Intel[®] Mobile Pentium[®] III Processor Specification Update

Release Date: October 2000

Order Number: 245306-012

The Mobile Pentium[®] III processor may contain design defects or errors known as errata which may cause the product to deviate from published specifications. Current characterized errata are documented in this Specification Update.

Figure 7. BCLK Timing Waveform

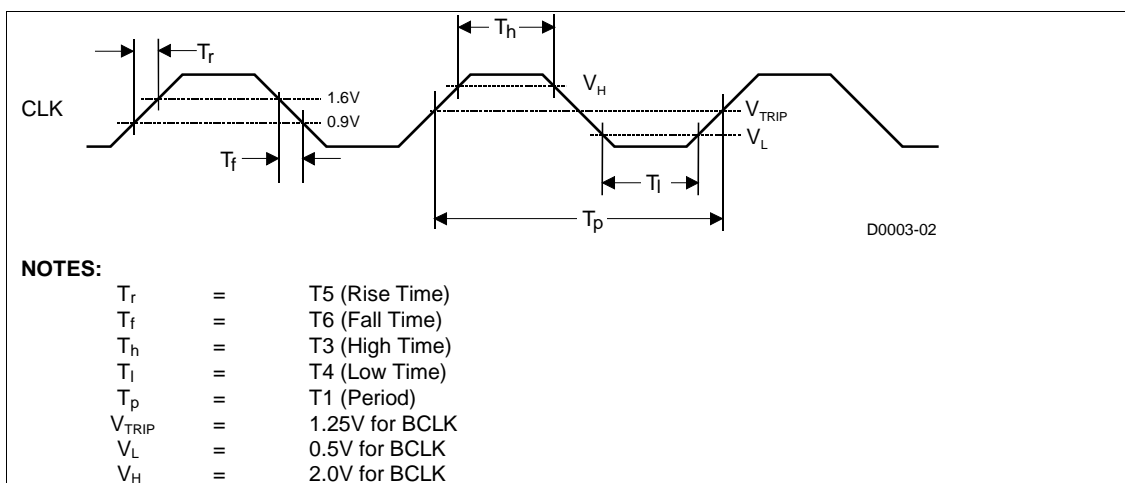
For B0 step processors, the $V_{IH,BCLK}$ Min spec is changed to 2.0V (from 1.7V for A2 step) and $V_{IL,BCLK}$ Max spec is changed to 0.5V (from 0.7V for A2 step). Due to this, new values are specified for BCLK high and low times for B0 step processors. These modifications affect corresponding specs in Table 13, Table 14, Table 24, and Figure 7 in *Mobile Pentium® III Processor in BGA2 and Micro-PGA2 Packages datasheet* (Order Number 245302-002).

The following tables and figures highlight the above mentioned BSEL[1:0] and BCLK specs modifications made for B0 step processors:

Symbol	Parameter	Min	Typ	Max	Unit	Figure	Notes
	System Bus Frequency		100		MHz		
T1	BCLK Period		10		ns	Figure 7	Note 2
T2	BCLK Period Stability			± 250	ps		Notes 3, 4
T3	BCLK High Time	2.70			ns	Figure 7	at >2.0V
T4	BCLK Low Time	2.45			ns	Figure 7	at <0.5V
T5	BCLK Rise Time	0.175		0.875	ns	Figure 7	(0.9V – 1.6V)
T6	BCLK Fall Time	0.175		0.875	ns	Figure 7	(1.6V – 0.9V)
